**Project Name:** Dollar General Beaufort

**CITY OF BEAUFORT  
DESIGN REVIEW BOARD  
Staff Report  
Meeting of June 16, 2016**

**Case Number:** 16-07 DRB.1  
**Project:** Dollar General  
**Property Address:** 2811 Boundary Street  
**Parcel #:** R120 026 00A 0275 0000  
**Zoning:** Highway Commercial  
**Design District:** US Highway 21 Design District  
**Type of Review:** Preliminary Review – New Construction

Sheet Title: **SITE PLAN**

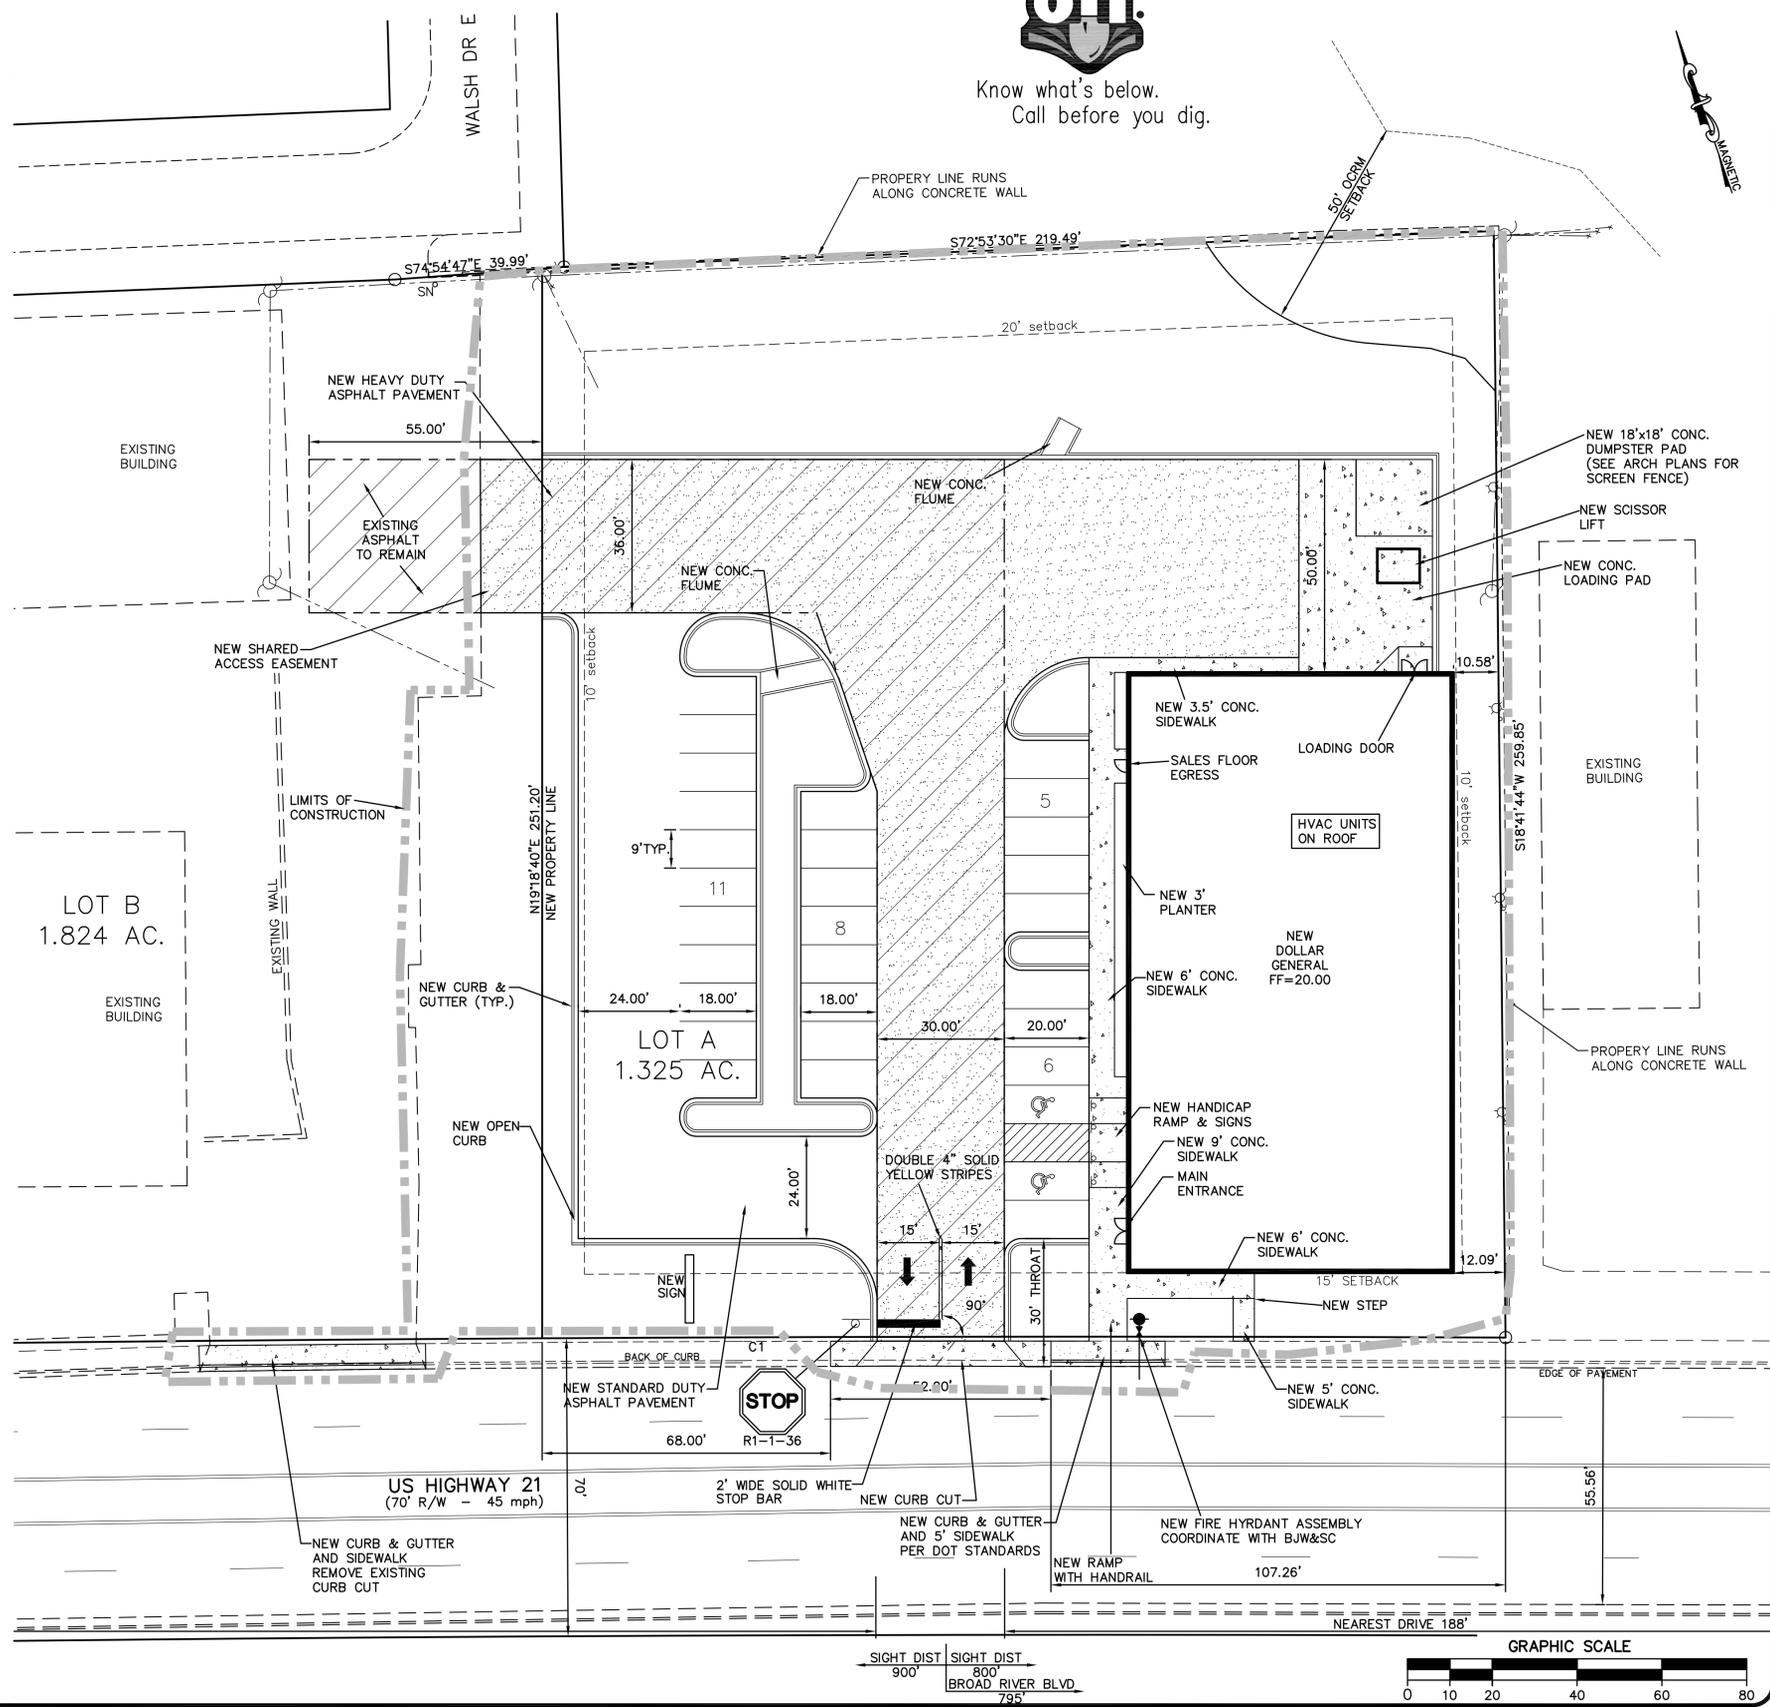
- Parking location and quantity, parking lot connectivity, pedestrian connectivity, and

- general layout all comply with the UDO.
- Is the landscaped median between parking stalls being used for stormwater infiltration?
  - Landscaping:
    - A tree survey, showing all trees 8” caliper or greater, is required. From previous discussion, there may not be any trees except the Sabal palmettos towards the front of the site. These should be shown for removal. If there are no additional trees, please indicate as such, and also indicate that no tree protection fencing is required.

- Is it possible to reduce the height of the poles, particularly the ones closest to the street? A more street-style light fixture would be appropriate to accompany this pole height reduction. This would be more consistent with the urban character of the building and site plan.

Sheet Title: **LANDSCAPE PLAN**

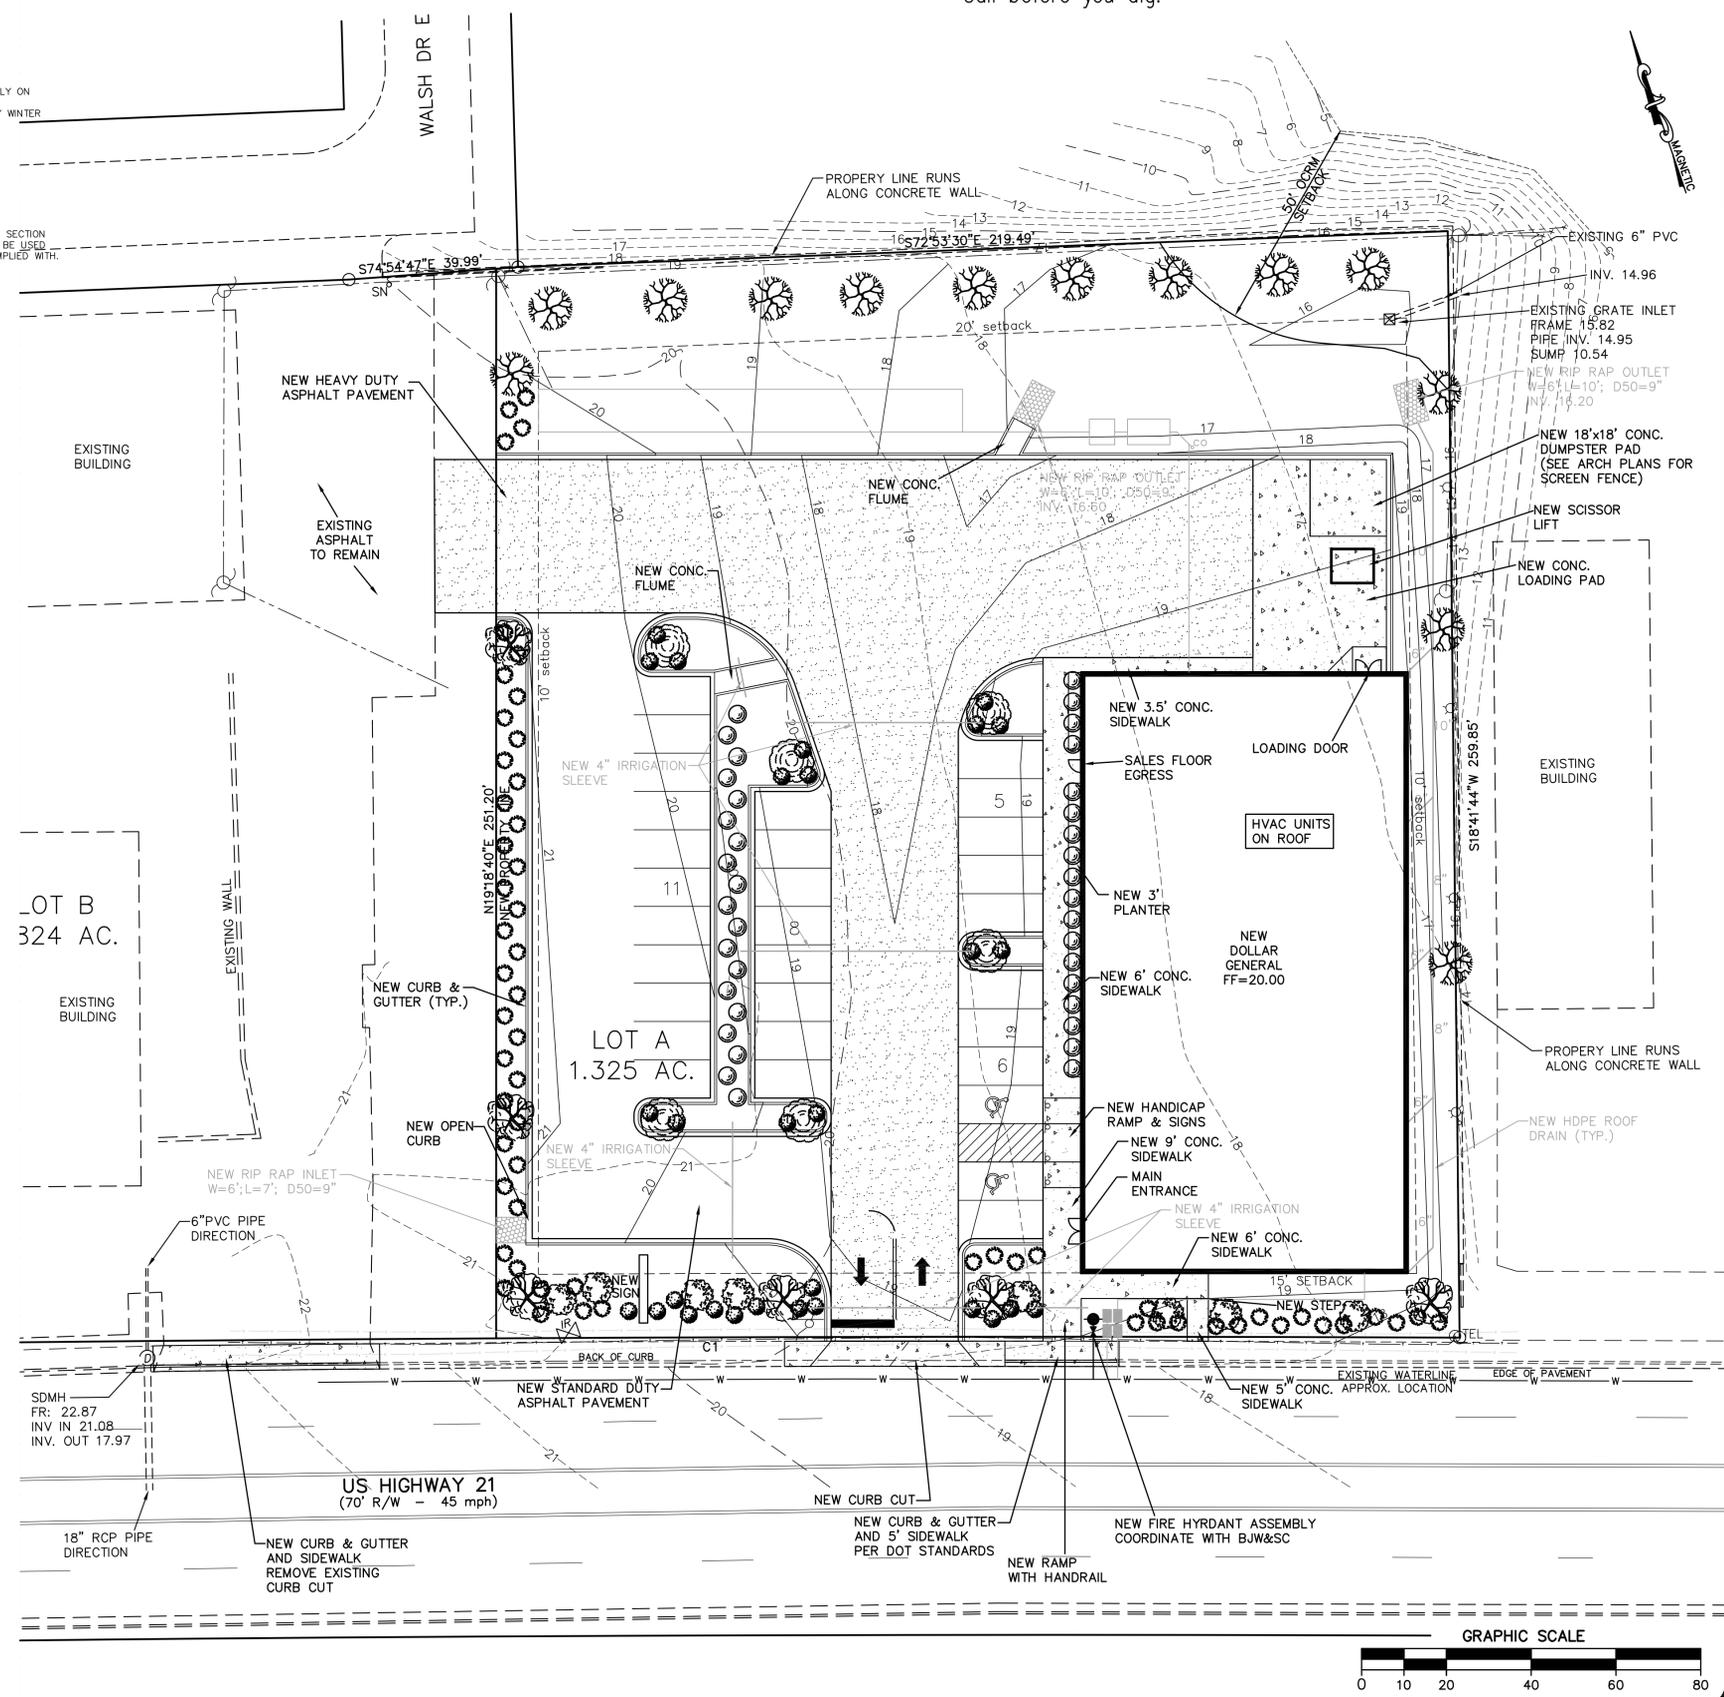
- Wheel stops (7.3.E.7.c.) required for protection of shrubs in center parking aisle.
    - Shrubs used for screening of parking lots shall be 2.5’ in height at time of installation. Shrub height not specified in plant schedule.

- Planting requirements and recommendations:
      - Highway 21 buffer requires one additional overstory and one additional understory tree. Given the urban siting of this building, we can be flexible with this requirement, however consider adding another willow oak to the east of the sidewalk coming into the building. This would create a rhythm of street trees along the site.

- Highway 21 buffer displays 37 shrubs. 25% of buffer is 723 SF. On center spacing not provided in plant schedule. Assuming average recommended spacing for Yaupon and Burford Holly as specified of 3.5’ o.c., there is a shortfall of 270 SF requiring addition of 22 shrubs. Again, given the urban siting, and canopy coverage, we can be flexible, but the addition of as many shrubs as practical to try to achieve this coverage is required. An additional layer in front of the drive area may help to achieve this, as would more foundation planting on the east portion of the front elevation.

- The Red Maple species/variety not specified. Consider an alternative tree as Red Maples do not do well as parking lot trees. Alternate tree types to consider include, but are not limited to, Bald Cypress, Allee Elm or Swamp Chestnut Oak.

- Consider using fastigate shrub form such as Podocarpus as accent to provide some vertical height on blank wall area flanking sales floor egress on west façade.

- Request shrub/palm/small tree planting on unfenestrated east façade, particularly on the front portion closest to Boundary Street.
  - Lighting:

Drawing Title: **EXTERIOR ELEVATIONS**

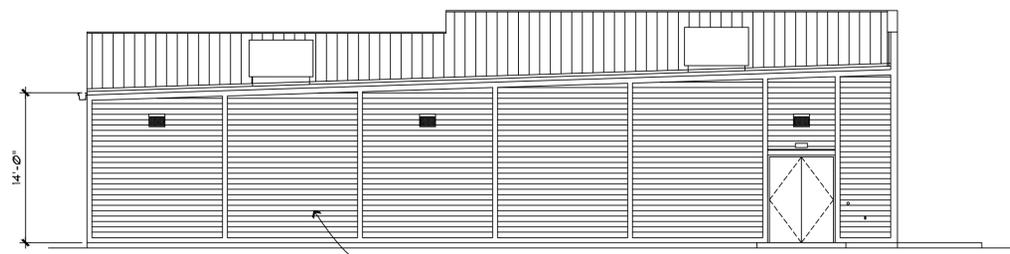
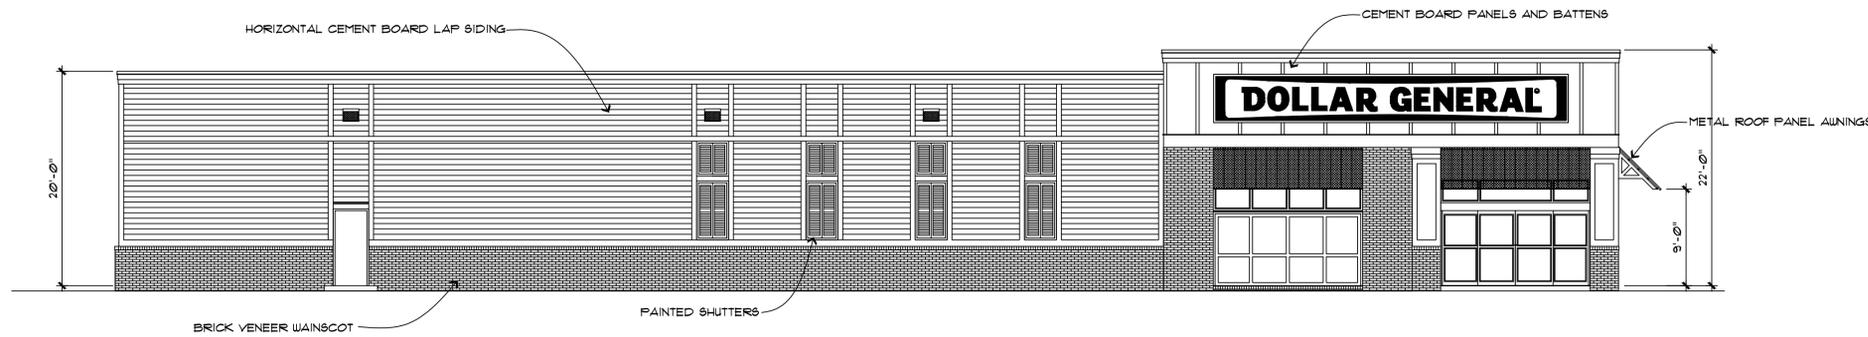
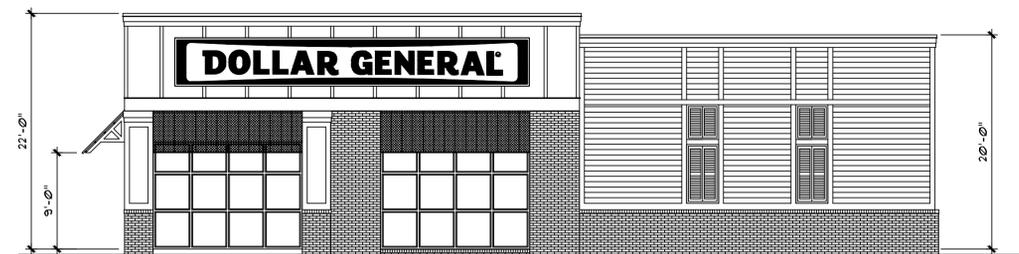
- Is it possible to include a more decorative lighting fixture on the Boundary Street elevation?
    - It looks like some of the wall packs are shown on the elevations, but others do not appear.

- On the west elevation, the drawing shows the fenestration under the left-most awning as a panel, while the rendering shows it as windows. Please clarify. A window would be ideal.
  - The lite divisions in the rendering, on the left-most window on the south elevation, don't match the elevation.
  - Consider making the divisions, whether panelized or glazed, the same as the other window divisions.
- Details of the wall sections, parapets, window head/sill/jamb and awnings will be required.
- A full materials list for all items including shutters, windows, columns, and dumpster enclosure doors, will be required.
- Colors, per the rendering, are appropriate.
